Remarks:

Amendments to the Drawings:

FIG. 28

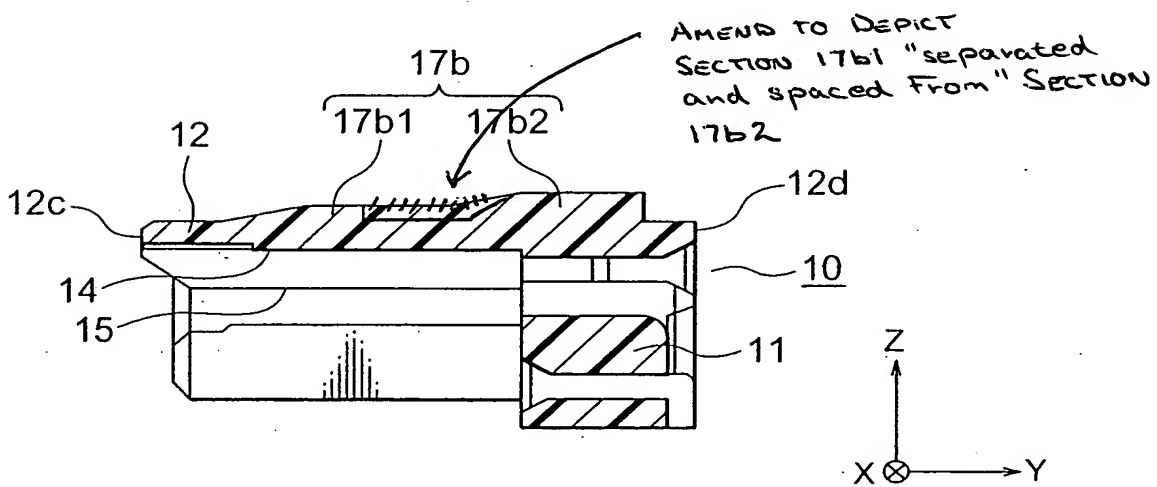
The attached sheet of drawings includes changes to **Fig. 28**. This sheet, which includes **Fig. 28**, replaces the original sheet including **Fig. 28**. In amended **Fig. 28**, Applicants depict the two sections 17b1 and 17b2, which comprise material raised portions 17b. In accordance with the specification, “the section 17b1 is separated and spaced from the section 17b2 in the Y-direction.” Appl’n, Para. [0071] (emphasis added). Moreover, sections 17b1 and 17b2 depicted in **Fig. 28** are distinguishable over sections 17a1 and 17a2, which constitute “one material-raised portion 17a . . . arranged on a single imaginary line extending in the Y-direction.” Appl’n, Para. [0070].

Applicants are amending the specification to correct two typographical errors in Paras. [0057] and [0058] and are amending the drawings to include corrections to **Fig. 28**, so that **Fig. 28** conforms to the description in the application. Applicants also are amending claim 1 to include limitations of claims 2-5 and are cancelling claims 3-5, without prejudice. Further, Applicants are amending claims 1, 2, and 6-17 to clarify the description of the claimed invention and to address the objections to these claims. No new matter is introduced by these amendments and the amendments are fully supported by the specification, as filed. E.g., Appl'n, Para. [0053], [0070], and [0071]. As a result of these amendments, claims 1, 2, and 6-17 are pending in this application. No fees are believed due as a result of these amendments. Nevertheless, in the event of any variance between the fees determined by Applicants and those determined by the PTO, please charge or credit that variance to the undersigned's Deposit Account No. 02-0375. Applicants respectfully request that the Examiner enter these amendments and reconsider this application in view of the foregoing amendments and the following remarks.
